May 12, 2020  
RA-19-0359

Shearon Harris Nuclear Power Plant, Unit 1  
Docket No. 50-400/Renewed License No. NPF-63

Subject: License Amendment Request to Correct Non-Conservative Technical  
Specification 3/4.4.9, "Pressure/Temperature Limits – Reactor Coolant System"

Technical Specifications Markup

FIGURE 3.4-2  
REACTOR COOLANT SYSTEM  
COOLDOWN LIMITATIONS - APPLICABLE TO UP TO 36 EF PY

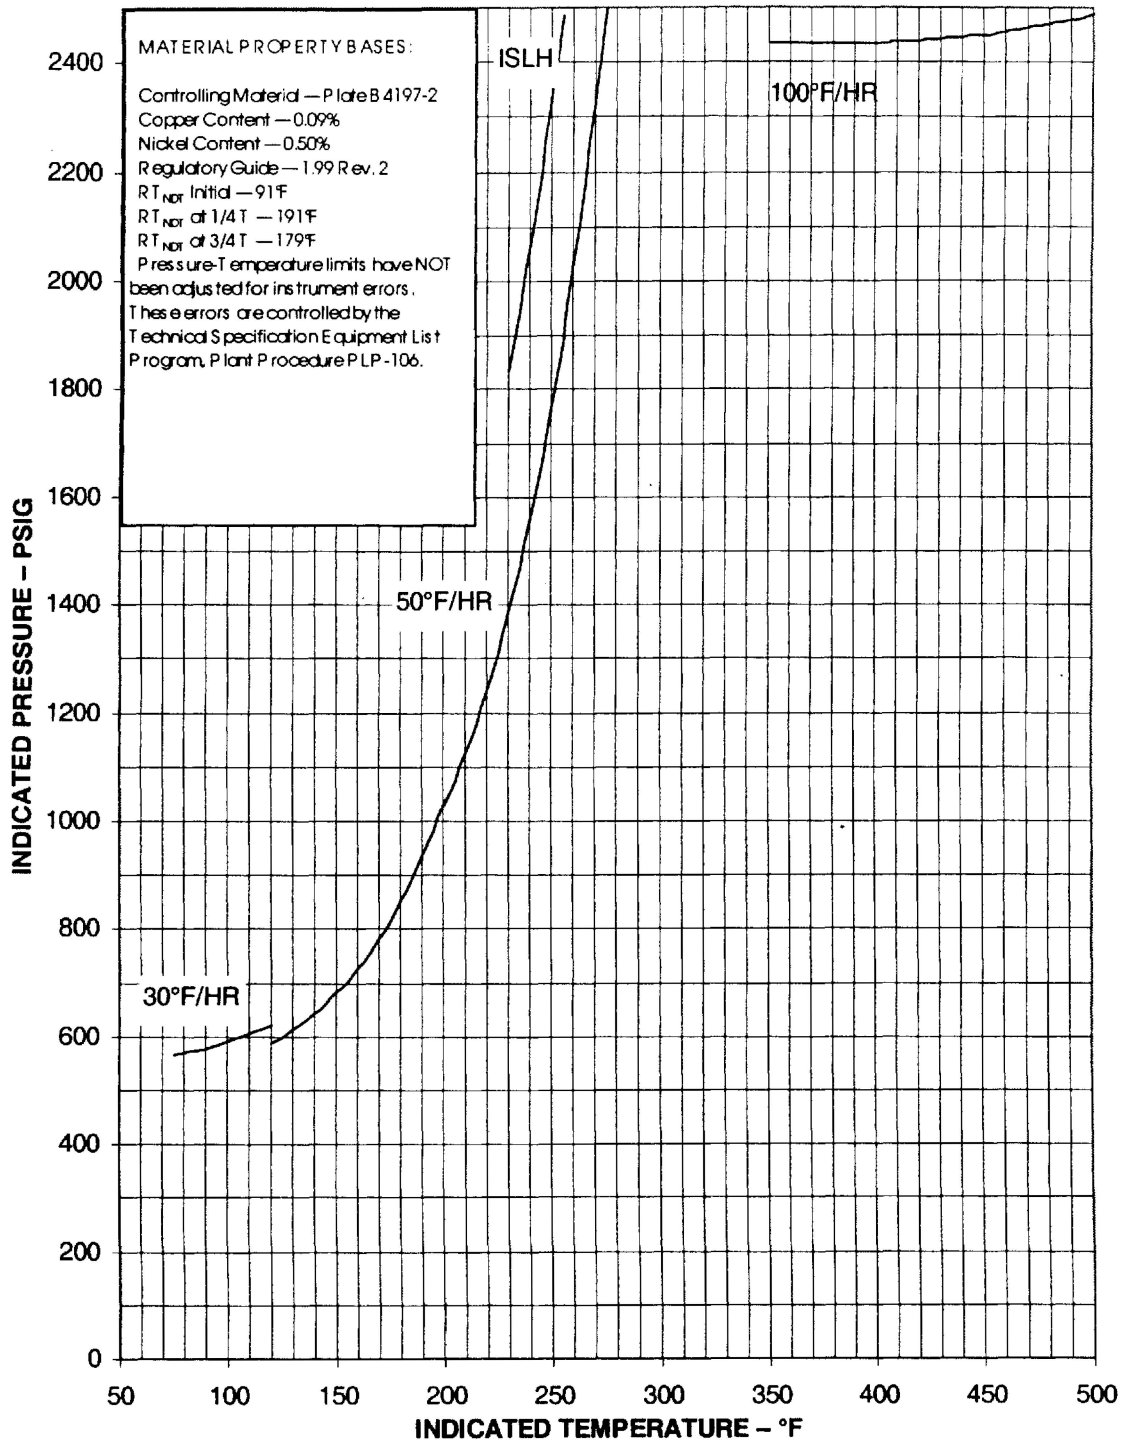
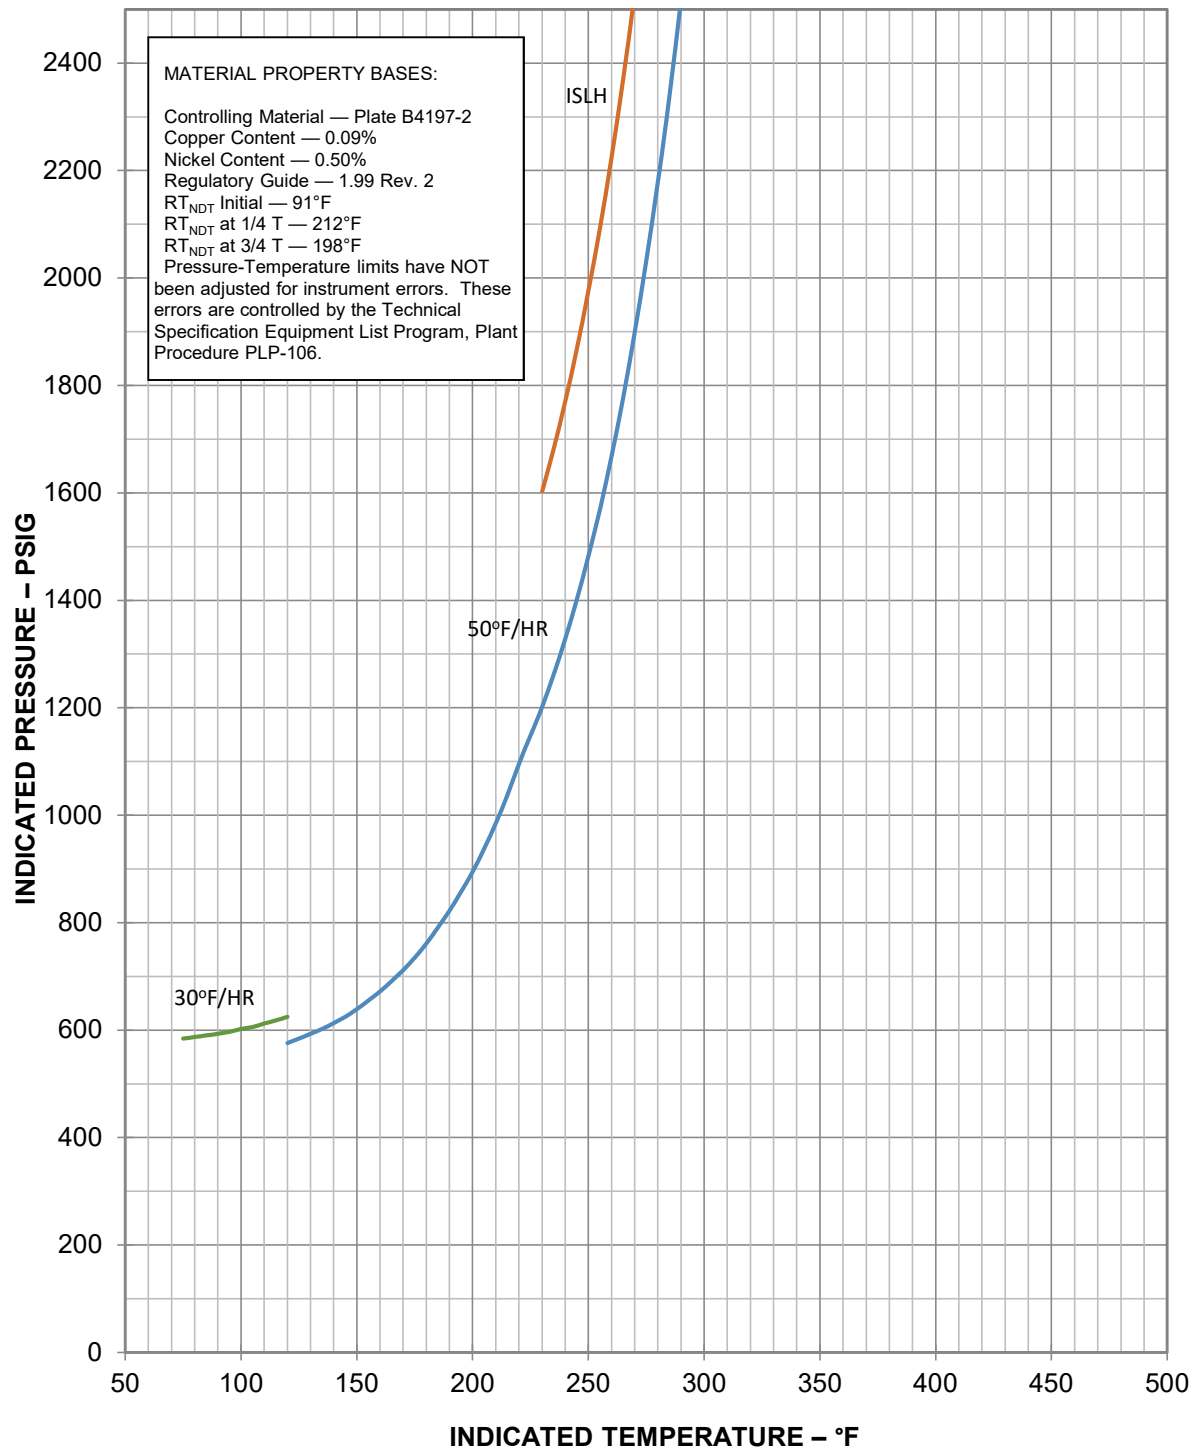
TS Figure 3.4-2, "Reactor Coolant System Cooldown Limitations – Applicable to Up to 36 EFPY," is revised as follows:

- The existing RCS cooldown limitations curves are superseded entirely by new curves applicable up to 55 EFPY.
- The cooldown limitations curve for a rate of "100°F/HR" is removed.
- The "RT<sub>NDT</sub> [reference nil-ductility temperature] at 1/4 T" value of "191°F" is revised to "212°F" in the "Material Property Bases".
- The "RT<sub>NDT</sub> at 3/4 T" value of "179°F" is revised to "198°F" in the "Material Property Bases".
- The title of Figure 3.4-2 is revised to state "Reactor Coolant System Cooldown Limitations – Applicable Up to 55 EFPY".

Note that the existing TS Figure 3.4-2 (Cooldown Limitations) contains a P/T limit curve for a cooldown rate of 100 °F/HR. The proposed change (i.e., revised Figure 3.4-2) does not contain a curve for the cooldown rate of 100 °F/HR because when the RCS fluid temperature is 290 °F or greater, the allowable pressure is above the reactor vessel design pressure of 2485 psig.

Replace with  
Insert #1

FIGURE 3.4-2  
REACTOR COOLANT SYSTEM  
COOLDOWN LIMITATIONS—APPLICABLE UP TO 55 EFY

FIGURE 3.4-3  
REACTOR COOLANT SYSTEM  
HEATUP LIMITATIONS—APPLICABLE UP TO 36 EFPY

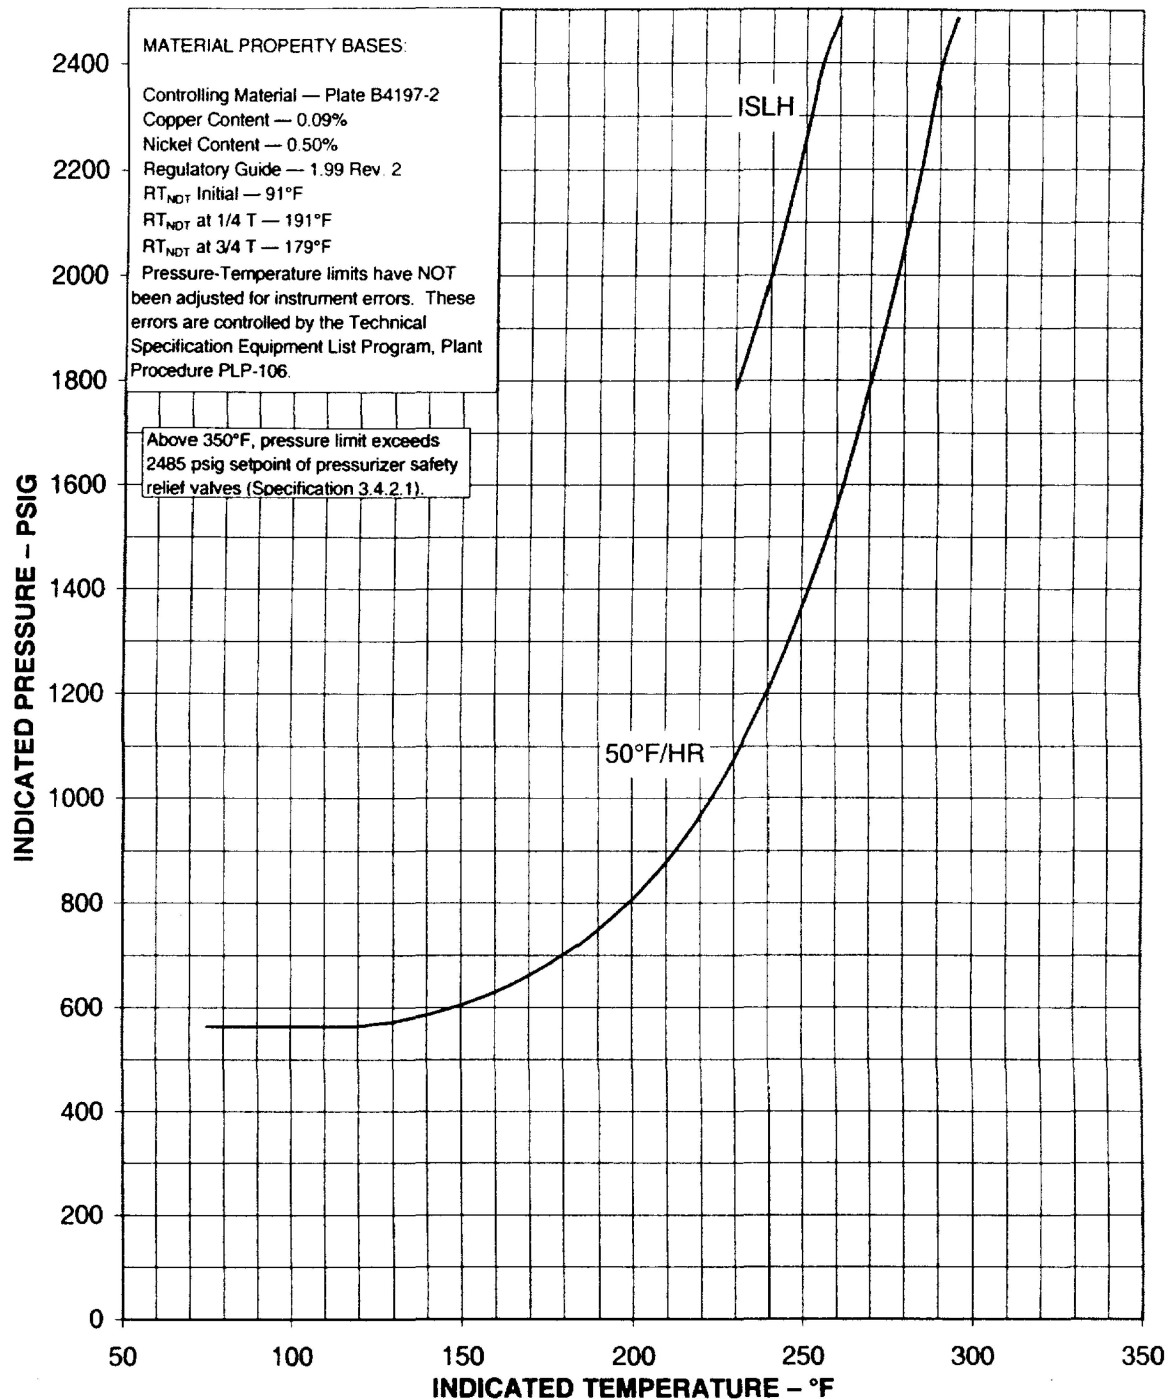
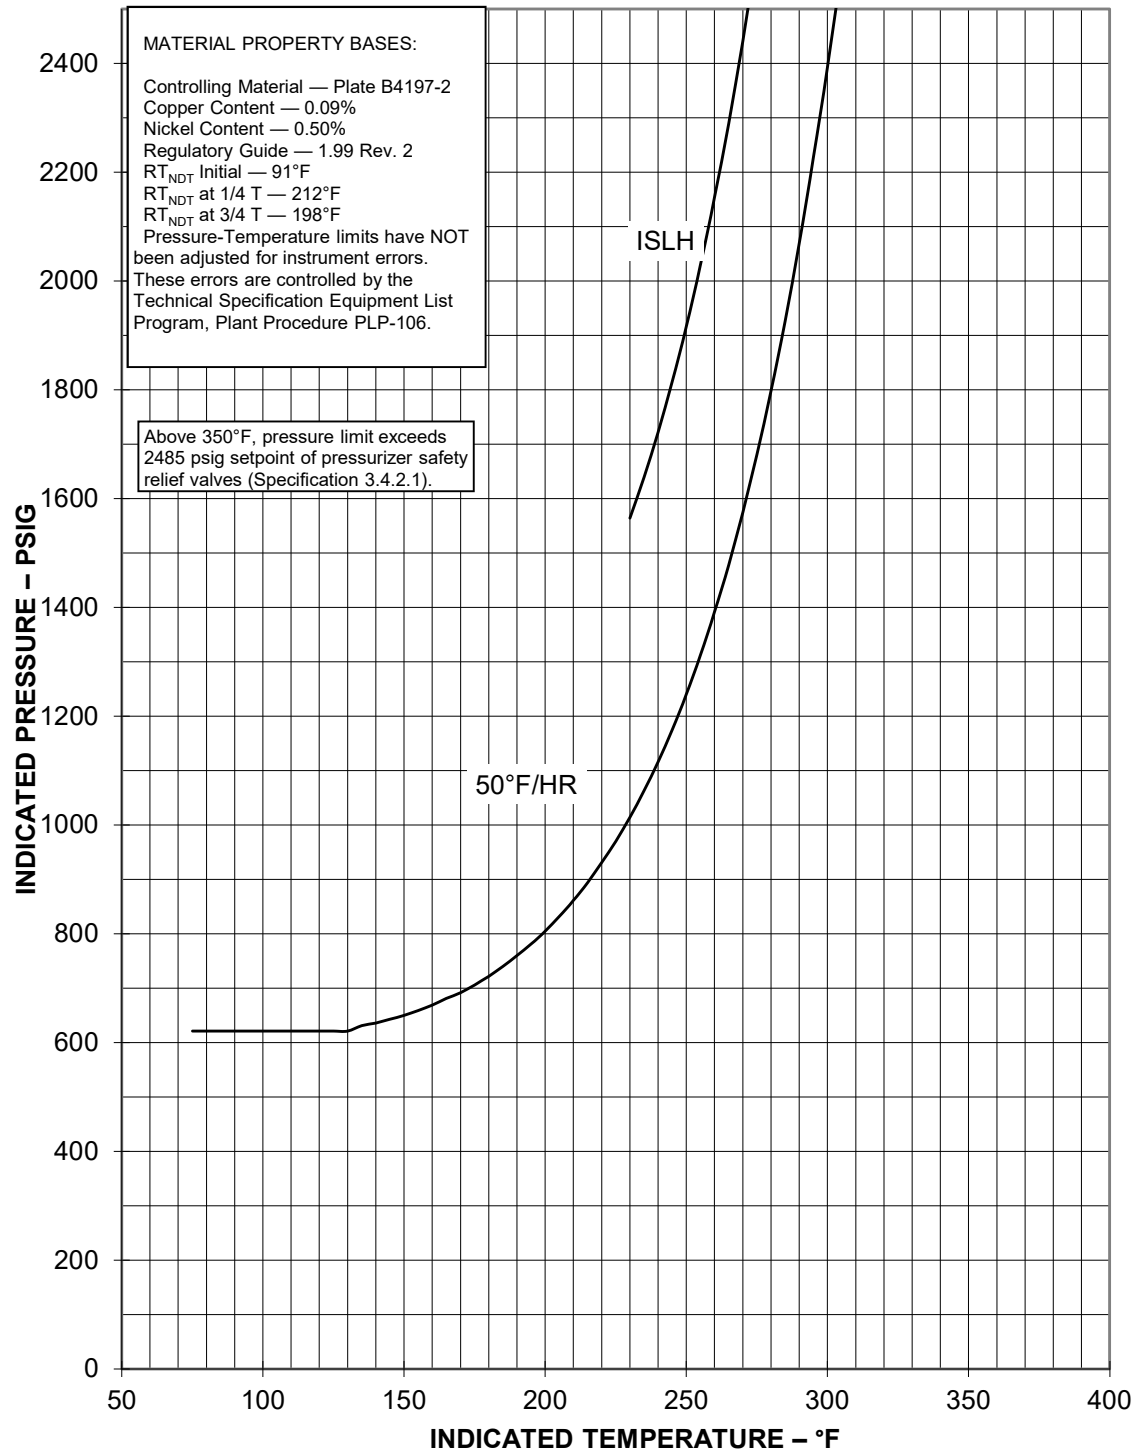
TS Figure 3.4-3, "Reactor Coolant System Heatup Limitations – Applicable Up to 36 EFPY," is revised as follows:

- The existing RCS heatup limitations curves are superseded entirely by new curves applicable up to 55 EFPY.
- The "RT<sub>NDT</sub> at 1/4 T" value of "191°F" is revised to "212°F" in the "Material Property Bases".
- The "RT<sub>NDT</sub> at 3/4 T" value of "179°F" is revised to "198°F" in the "Material Property Bases".
- The title of Figure 3.4-3 is revised to state "Reactor Coolant System Heatup Limitations – Applicable Up to 55 EFPY".

Replace with  
Insert #2

FIGURE 3.4-3  
REACTOR COOLANT SYSTEM  
HEATUP LIMITATIONS—APPLICABLE UP TO 55 EFY

FIGURE 3.4-4

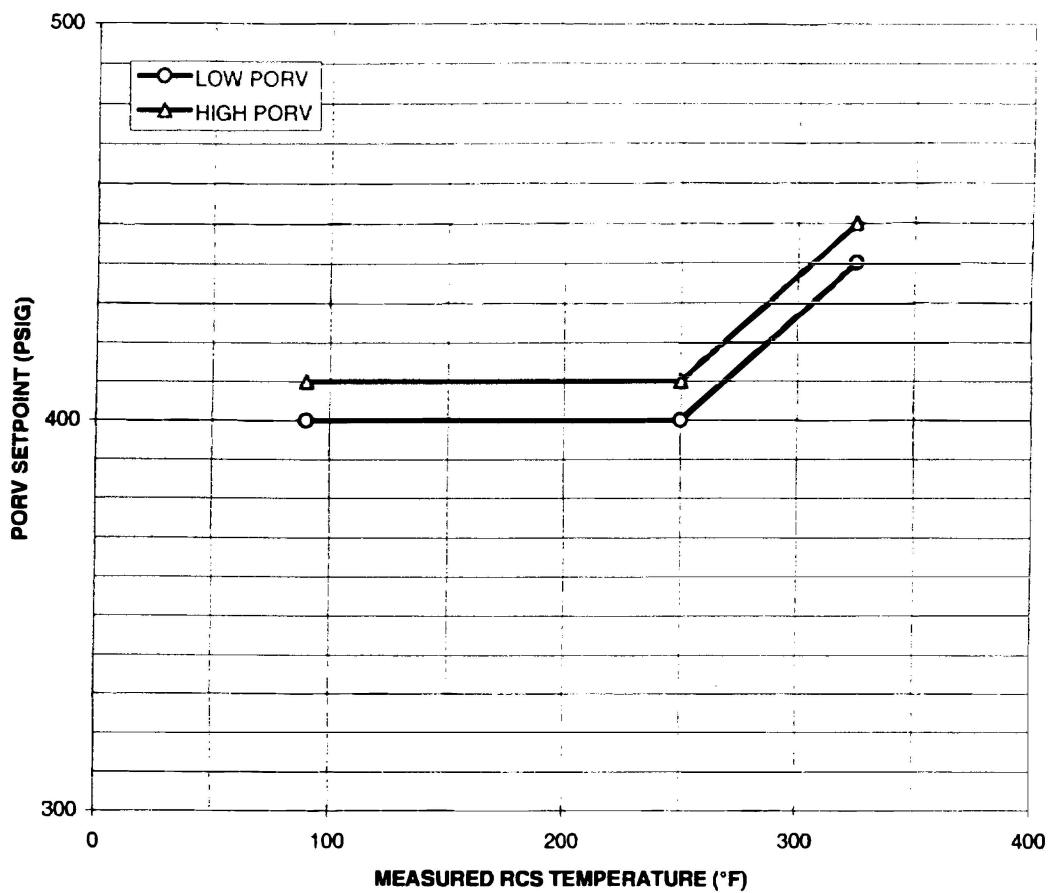
TS Figure 3.4-4, "Maximum Allowed PORV Setpoint for the Low Temperature Overpressure Protection System," is revised as follows:

- The note "\*VALUES BASED ON 36 EFPY REACTOR VESSEL DATA" is revised to state "\*VALUES BASED ON 55 EFPY REACTOR VESSEL DATA".

Change from 36 to 55

\* VALUES BASED ON ~~36~~ 55 EFPY REACTOR VESSEL DATA

FIGURE B 3/4.4-1  
FAST NEUTRON FLUENCE ( $E > 1\text{MeV}$ ) AS A FUNCTION OF FULL POWER SERVICE LIFE

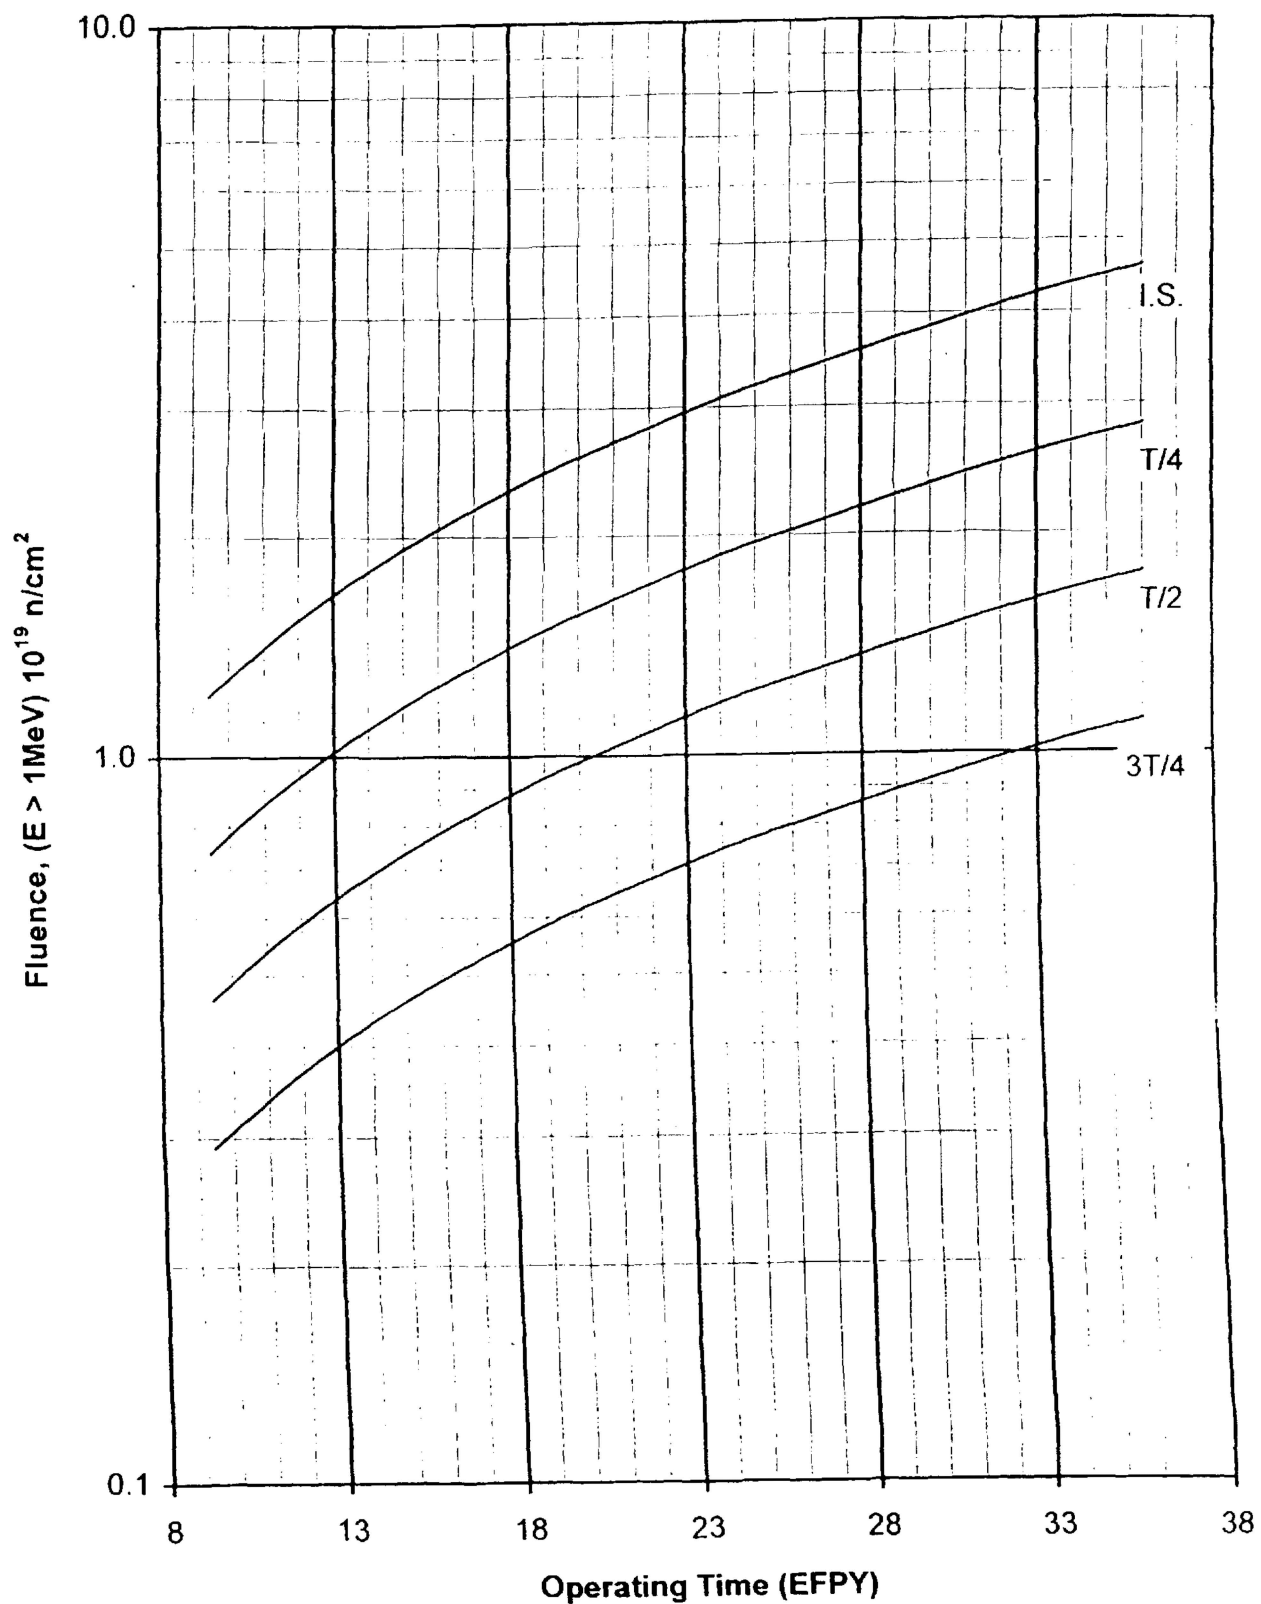
Delete this figure
